UNITED STATES  
NUCLEAR REGULATORY COMMISSION  
ADVISORY COMMITTEE ON REACTOR SAFEGUARDS  
WASHINGTON, D. C. 20555

SUBJECT: REVISED SUMMARY OF ACRS SUBCOMMITTEE MEETING TO  
REVIEW THE DRAFT REPORT OF THE DIABLO CANYON PEER  
REVIEW GROUP, JULY 11, 1984

MEETING SUMMARY  
ACRS SUBCOMMITTEE ON DIABLO CANYON  
REVIEW OF THE DRAFT REPORT OF THE DIABLO CANYON PEER REVIEW GROUP

## WELD DESIGN PROGRAM

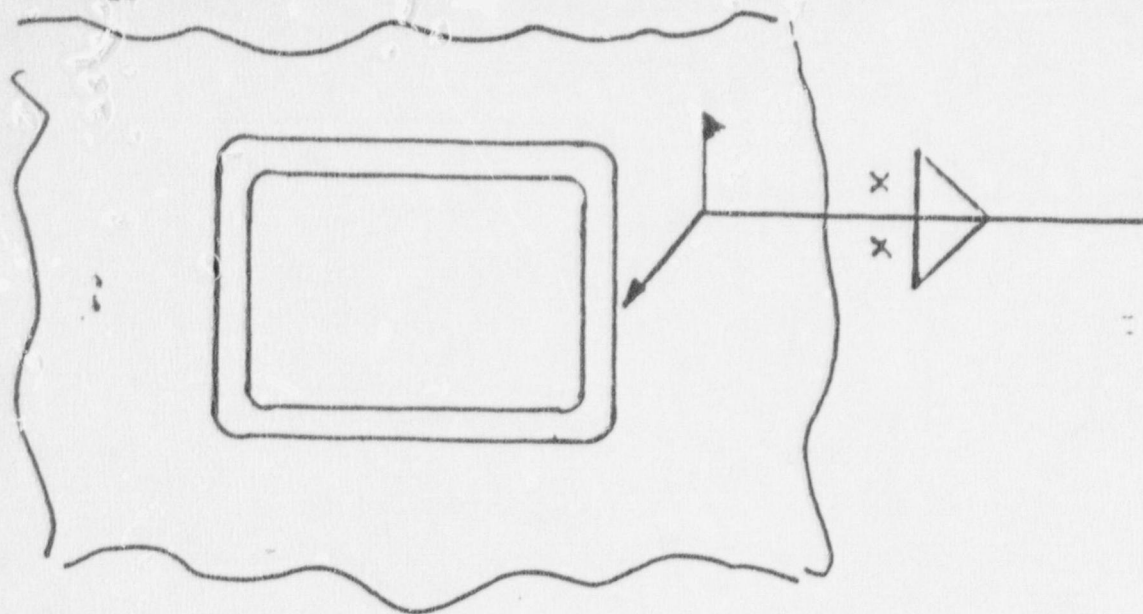
Weld symbols uses which require clarification on a re-occurring bases are referred to engineering for generic clarification. These are generally provided in formal letters issued by the Project Engineer. The following section illustrates a number of symbols used which are typical of those requiring clarification.

1. Typical single flare bevel symbol: No specified  $T_e$  noted on drawing implies  $T_e$  by design to be per AWS D1.1 with maximum  $T_e = 5/16R$ . Any greater  $T_e$  required by design will be stated explicitly.

2. Flare Bevel (See comment 1.).
3. Typical staggered fillet weld. Arrow side symbol to be same size as noted for other side symbol. Design intent is that both side symbol to be dimensioned per AWS.

4. Single bevel groove weld. Bevel and included angle the same. Angle to be as per either pre-qualified or specially qualified procedure. Any deviation outside of code essential variables if so noted to be reviewed by engineer. No included angle required to be noted unless specific requirement of design engineer.

5. Typical square groove butt weld. Future design use will specify both  $T_e$  required and root opening if weld has structural value. This symbol will be used in the future to denote a "seal weld" if weld is not structural and will be noted in the tail as such.

6. (See comment 5.).
7. Fillet weld on two sides both fillet weld sizes assumed same. Field to verify. Future per AWS both sides to be sized.
8. Single bevel groove weld with fillet cap. Interpretation and assumption requires design engineer clarification or construction As-builtting.

9. Fillet weld on two sides. Intent is for fillet weld on right and left sides of shape. Future design will arrow both sides requiring weld deposit plus length of required weld. Also, wrap around requirement will be stated (See Attachment 2-1).

10. Fillet weld for size onsize tublar steel. Size on size tublar steel one weld symbol as shown not sufficient. Requires a fillet weld for 2 sides and a flare groove type weld for other two sides.
11. Fillet weld on 3 sides (See comment 1.).
12. Fillet weld on 3 sides. Symbol accepted as shown. No need to specify "3 sides."
13. Site engineer directive DCC 10263 and SFHo DCC 8039 Chron. 037390 (See Attachment No. 4) specified wrapping of corner when possible and in all cases the weld size and length to be noted on As-built drawing.
14. Fillet weld on 3 sides. Future only arrow side to be shown and only 3 sides to be welded (See comment 12.).
15. For SFHO engineer directive see DCC 7688 and DCC 7524 for explanation of joint design requirements, measurement and weld symbol.
